AS BUILTS

FIRE PROTECTION SYSTEM to serve TEXTRON AVIATION WEST CAMPUS W7-7 EAST DOCK RENOVATION ONE CESSNA BOULEVARD CITY OF WICHITA, KANSAS

BID DOCUMENTS

PPW TITLE SHEET

CU100

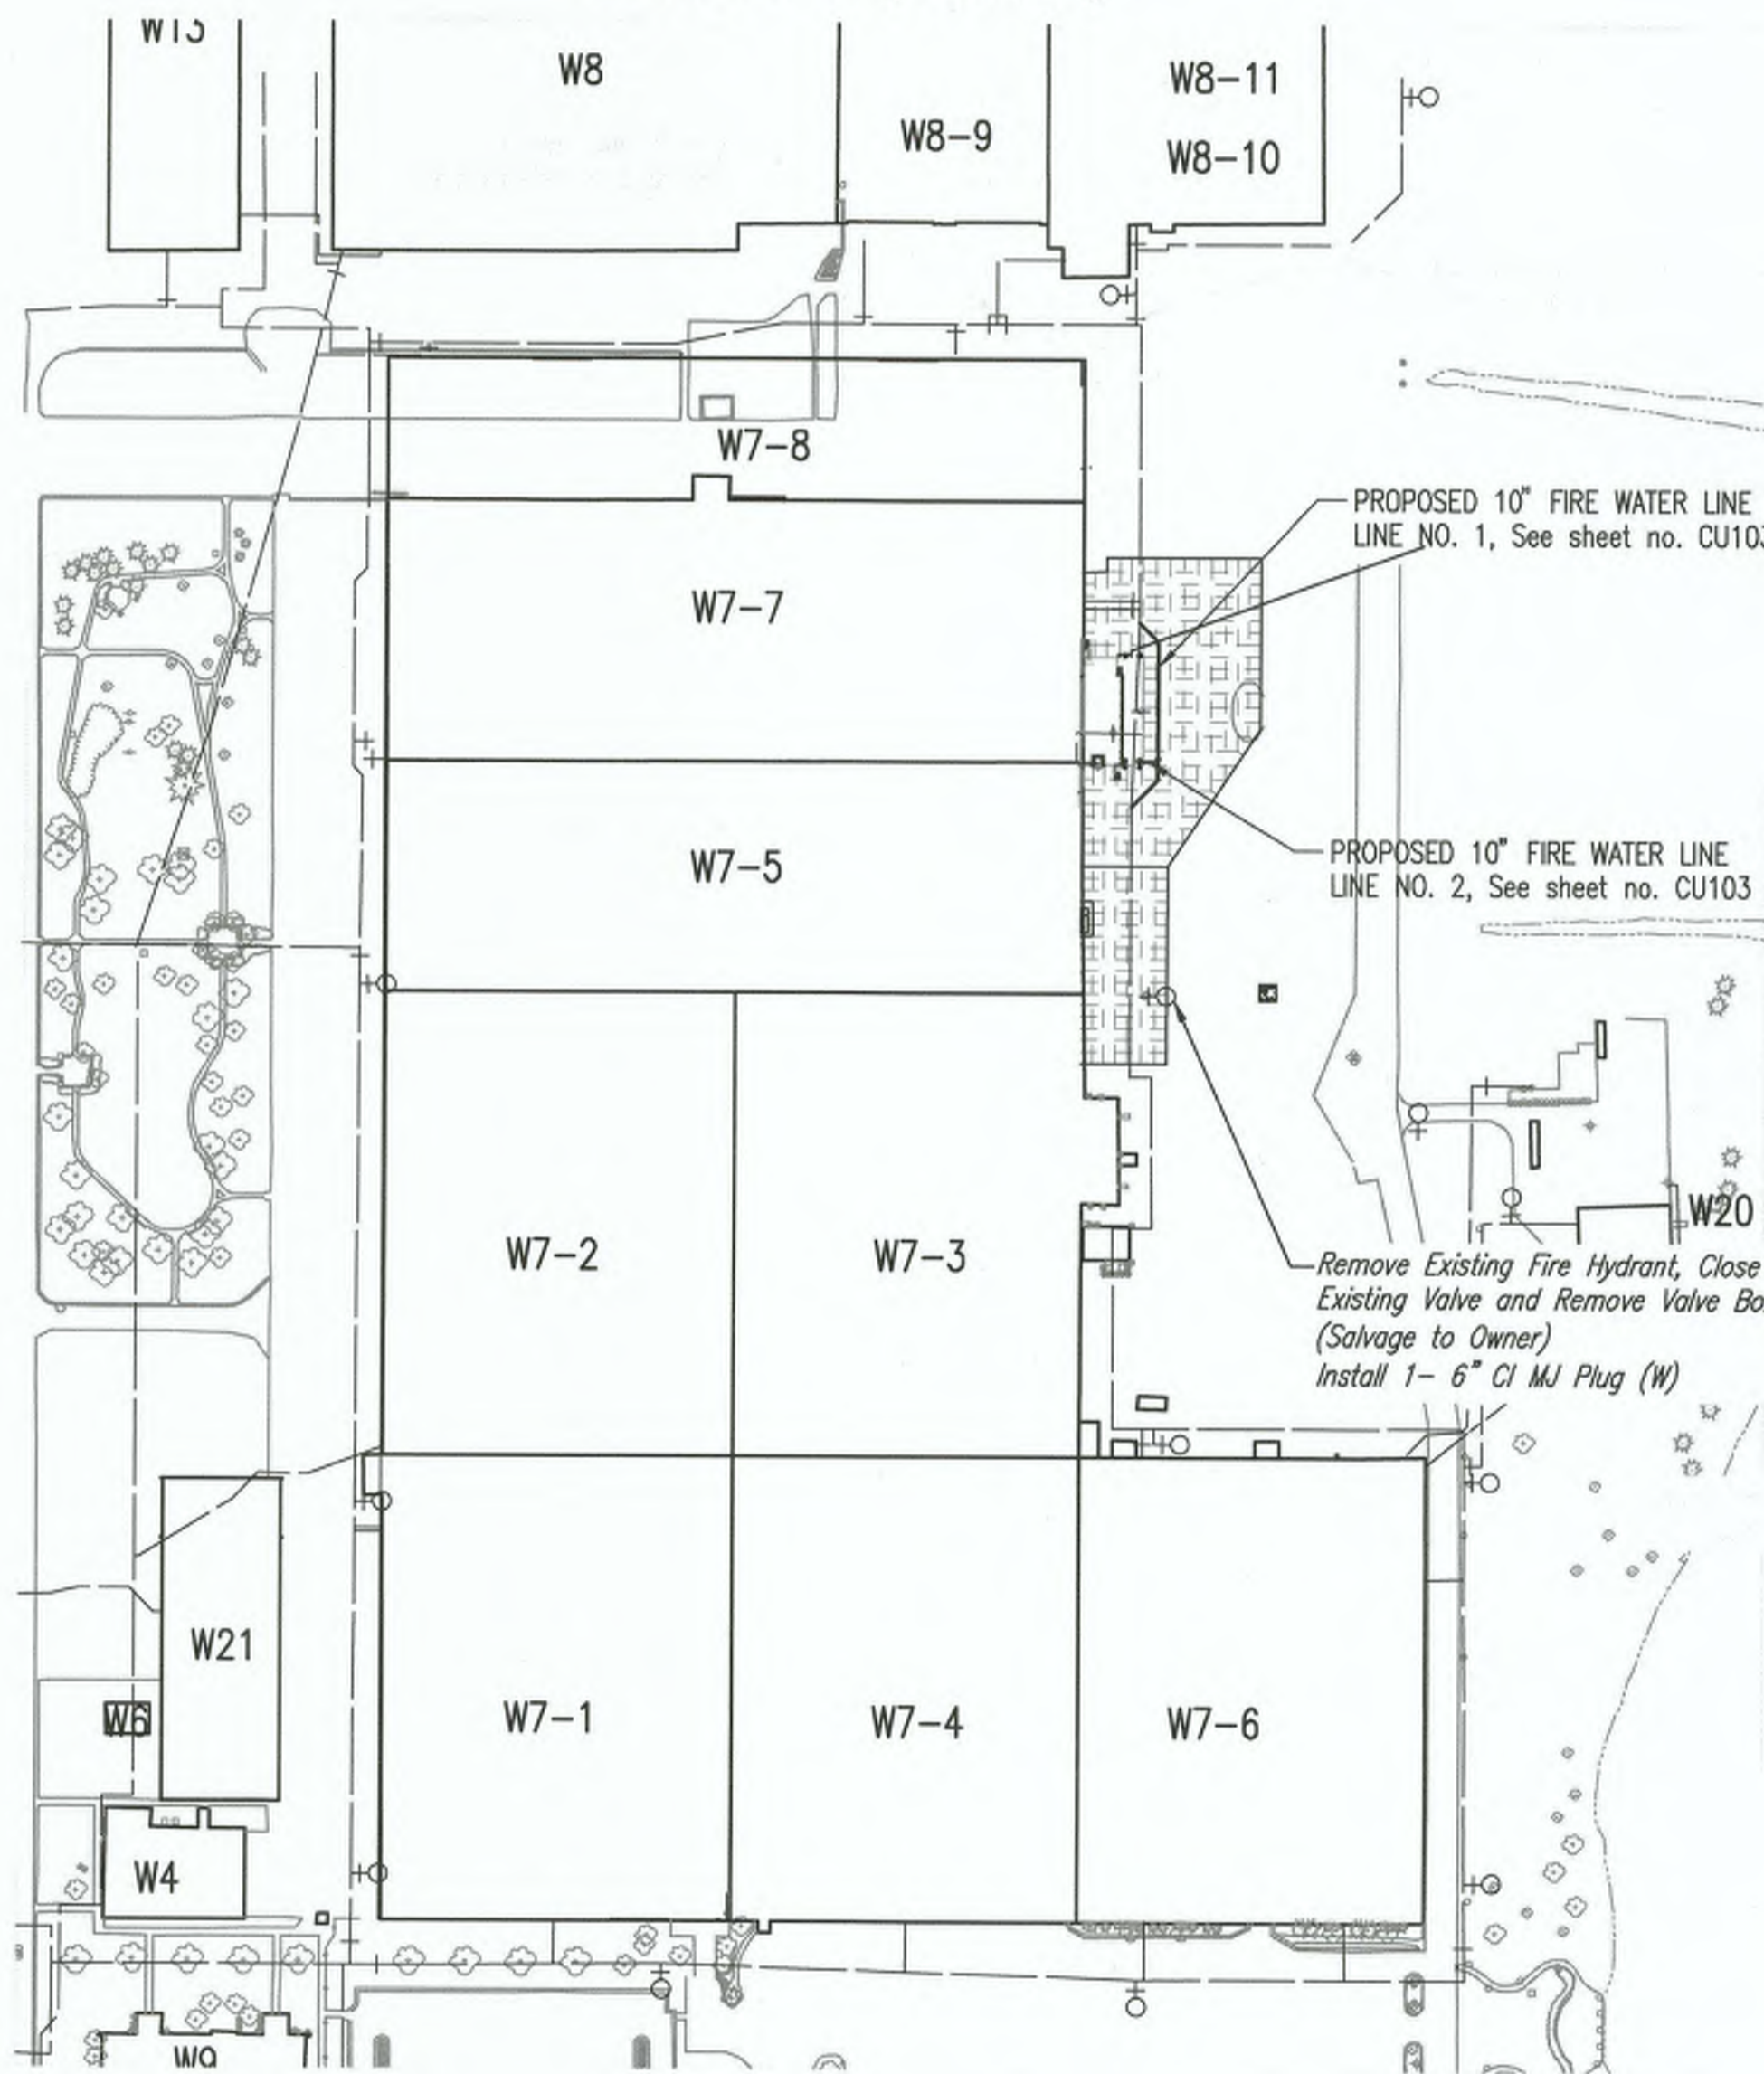
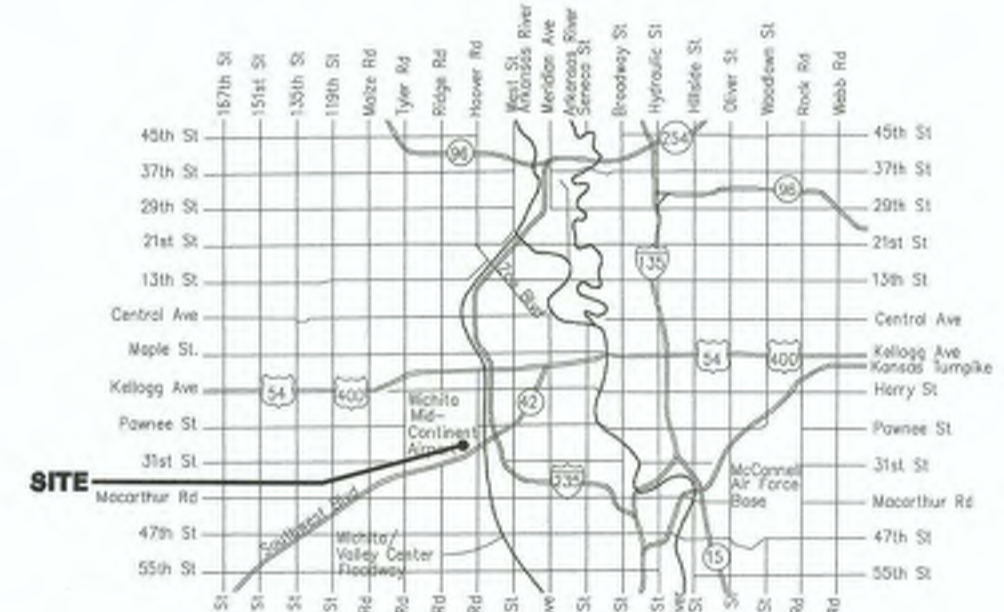
CLOW 10" VALVE
SIGMA FITTINGS
SIGMA MEGALUGS
TYLER UNION GLAND
PACKS
NAPO C-900
SANDERSON C-900

REMOVED
HYDRANT
PUT IN 10" CLOW
VALVE AND 2-
MEGALUGGED
LONG SLEEVES

TOP OF PIPE IS
8' TO PAVEMENT
DEEP
